Service Manual

MG125a

Model : MG125a

BOM CHANGE

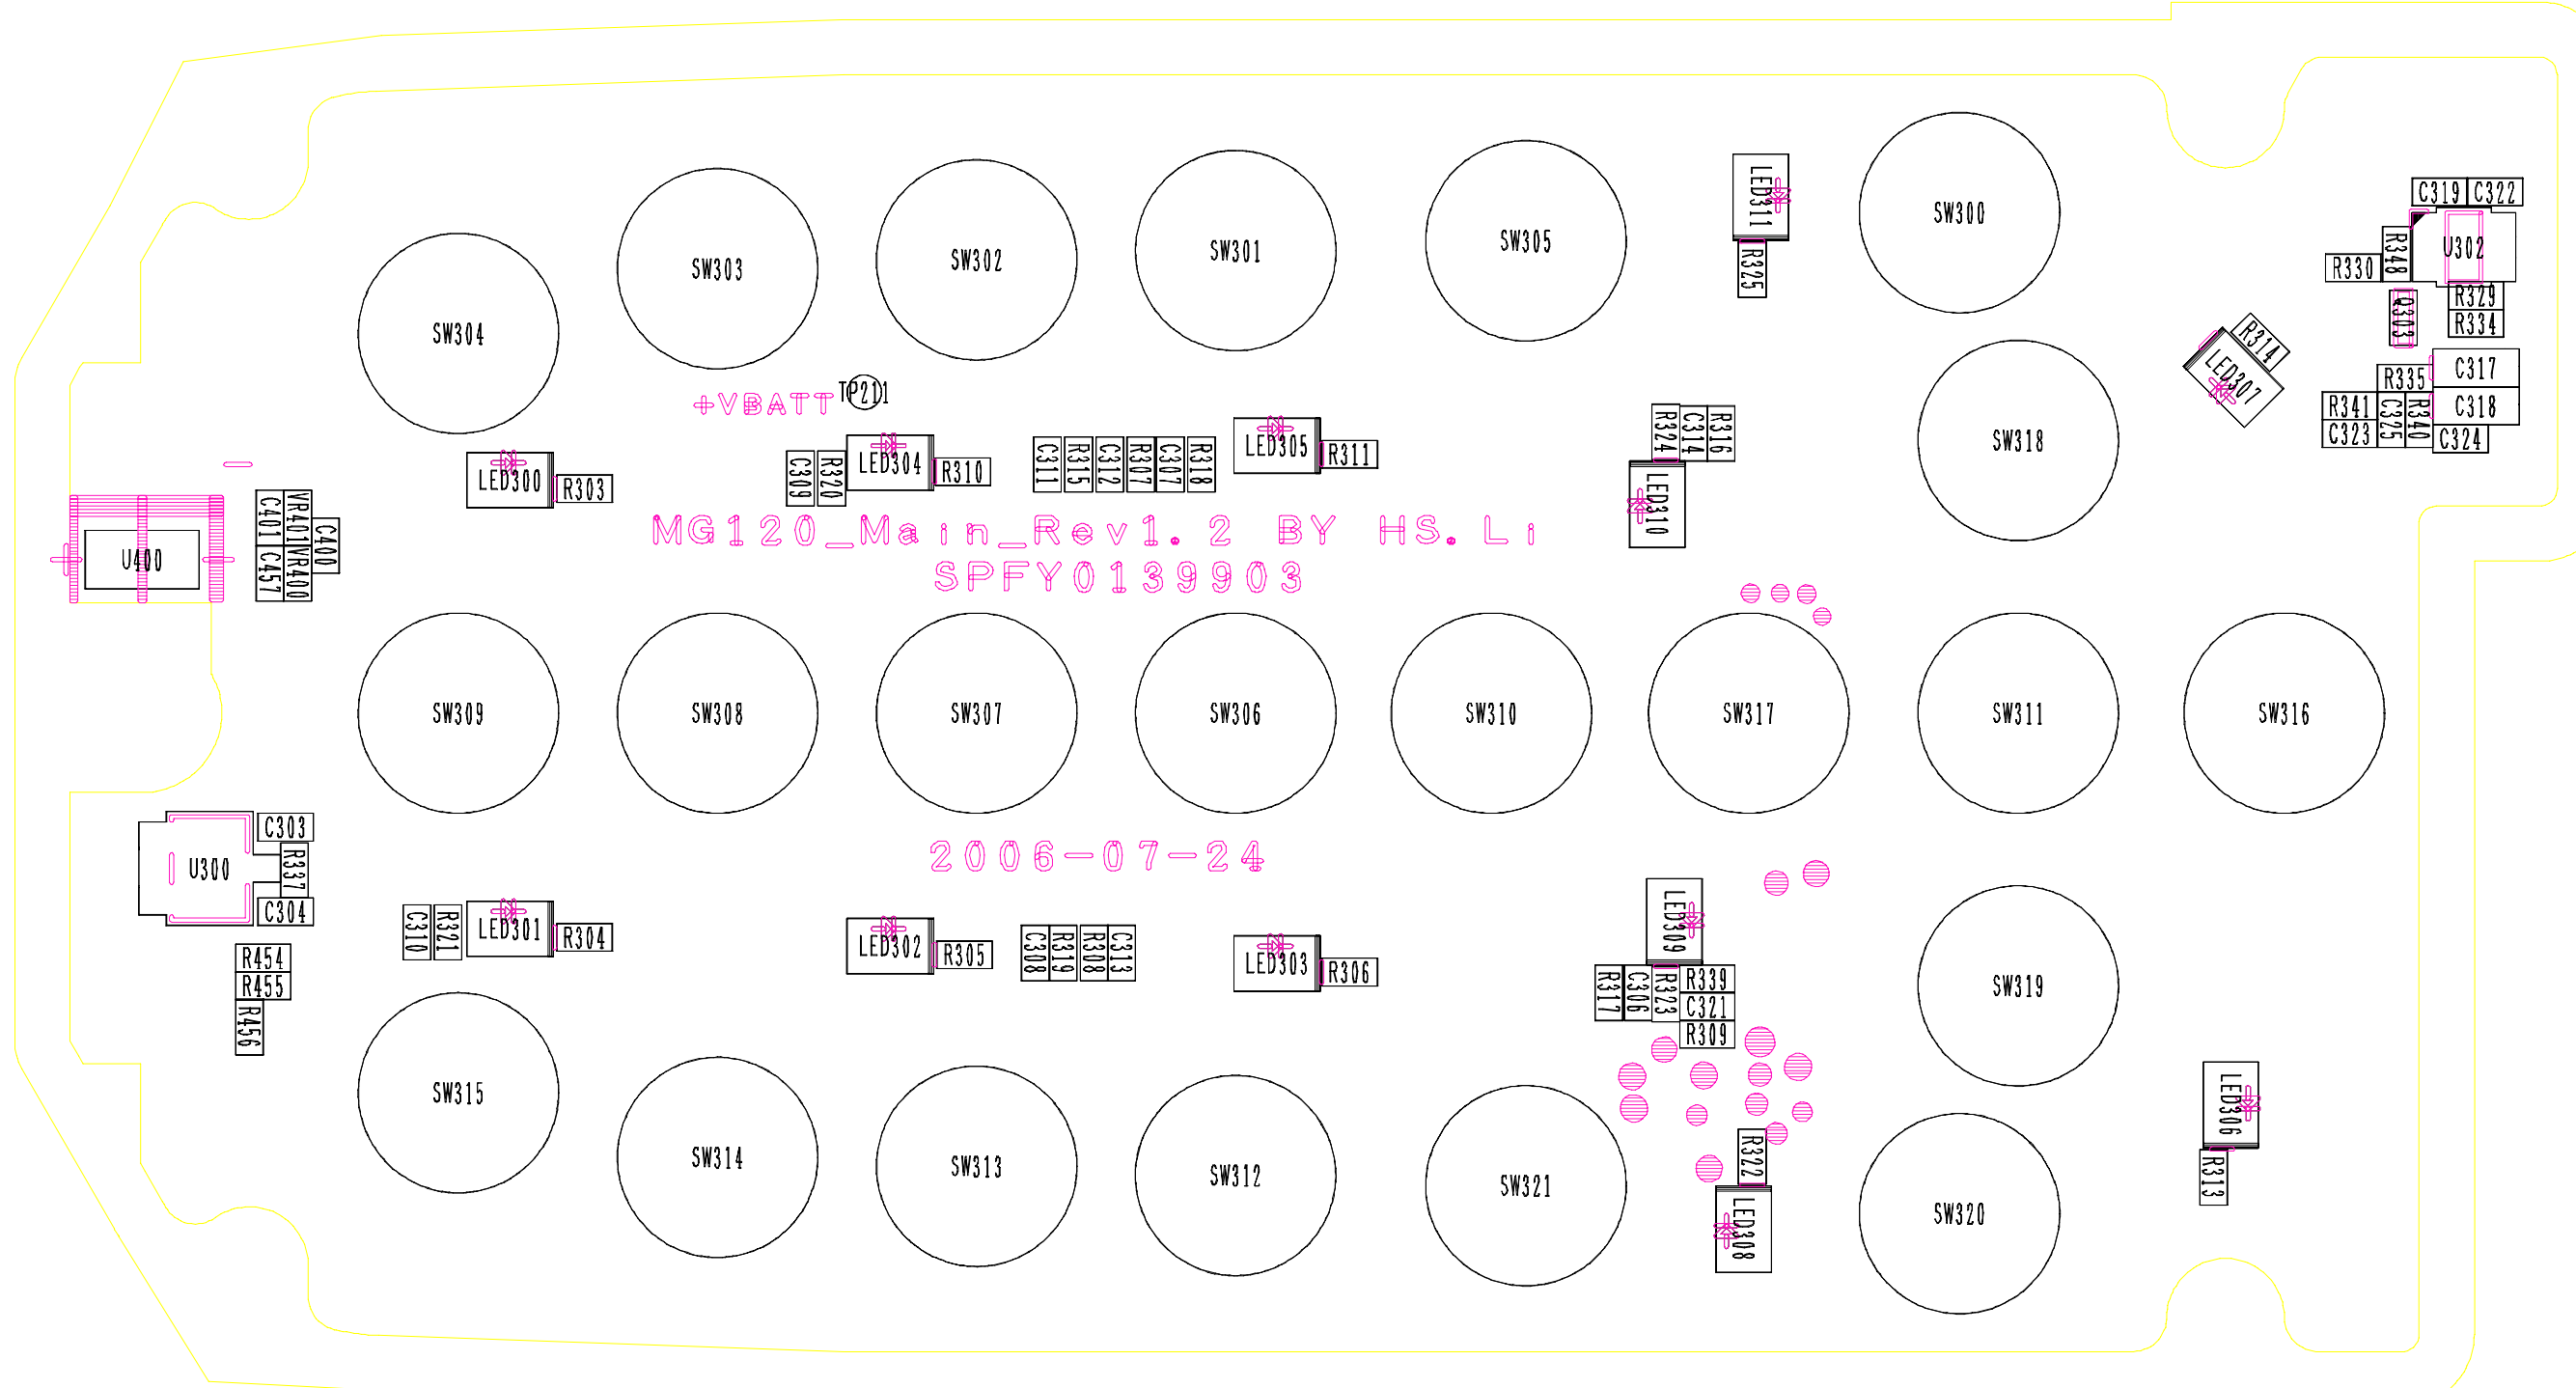
(06.07.22)

R469 (100p->200p)

C442 (100p->100n)
